Access Compliance Report

Public Rights-of-Way

(Curb Ramps)

Intersection ID: 5592	Main Street: COLIN_CREEK_LN	Cross Street: NORTHWOODS_FOREST_DR	Location:	N
ADA ID: 316461E9DDA1	Ramp Type: BlendTrans2	Initial Pass/Fail: Fail	Overall Compliance: No	Severity Score: 12.5
Codes/Mitigation Info/Possible Solution		Field Measurements/Component Compliance

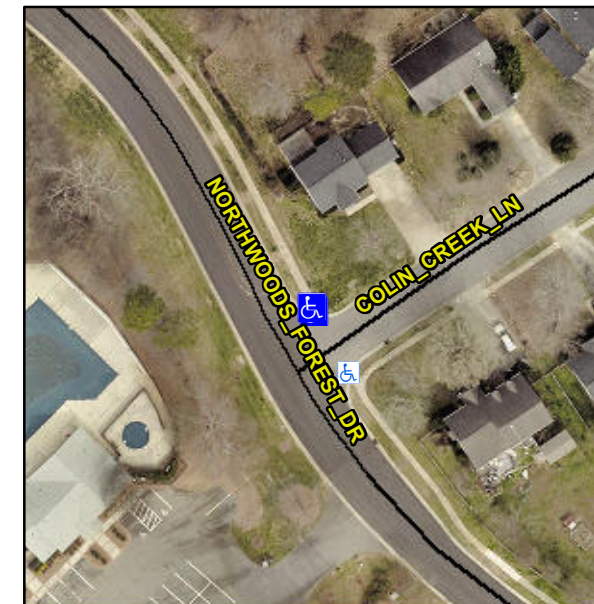
Not Found, R304.5.3

Compliance	Description	Data	Compliance	Description	Data
N/A	Ramp Length (in)	34.0	Yes	BlendTrans Slope (%)	3.0
Yes	Ramp Width (in)	48.0	No	BlendTrans XSlope (%)	6.6
N/A	Flare Type LT	N/A	N/A	Flare Type RT	N/A
N/A	Flare Slope LT (%)	N/A	N/A	Flare Slope RT (%)	N/A
N/A	Flare Traversable LT?	N/A	N/A	Flare Traversable RT?	N/A
N/A	Landing Length (in)	N/A	N/A	DWS Provided?	N/A
N/A	Landing Width (in)	N/A	N/A	DWS Contrast?	N/A
N/A	Landing Slope (%)	N/A	N/A	DWS Length (in)	N/A
N/A	Landing X Slope (%)	N/A	N/A	DWS Full Width?	N/A
N/A	Landing Curb? (Y/N)	N/A	N/A	DWS Offset (in)	N/A
N/A	Shared Landing?	N/A			
N/A	Gutter Ponding?	N/A	N/A	Gutter Slope (%)	N/A
N/A	Gutter Lip Ht (in)	N/A	N/A	Gutter X Slope (%)	N/A
N/A	Painted X Walk1?	No	N/A	Painted X Walk2?	N/A
	X Walk 1 Direction	To SE		X Walk 2 Direction	N/A
	X Walk 1 Width (in)	N/A		X Walk 2 Width (in)	N/A
	X Walk 1 Slope (%)	2.1		X Walk 2 Slope (%)	N/A
	X Walk 1 X Slope (%)	1.8		X Walk 2 X Slope (%)	N/A

N/A	Ramp inside XWalk1?	N/A	N/A	Ramp inside XWalk2?	N/A
	Road Slope (%)	1.8		Clear Space?	N/A
	Road X Slope (%)	2.1	N/A	Clear Space to XWalk (in)	N/A
N/A	Any Obstructions?	N/A	N/A	Storm Grate/Utility Hazard?	N/A
	Obstruction Type			Storm Grate/Utility Type	
		N/A			N/A
			Yes	Surface Condition? (G/P)	Good
			No	Curb Slope (%)	15.2

Remove & Replace Curb Ramp With Two New Directional Ramps or Equivalent.
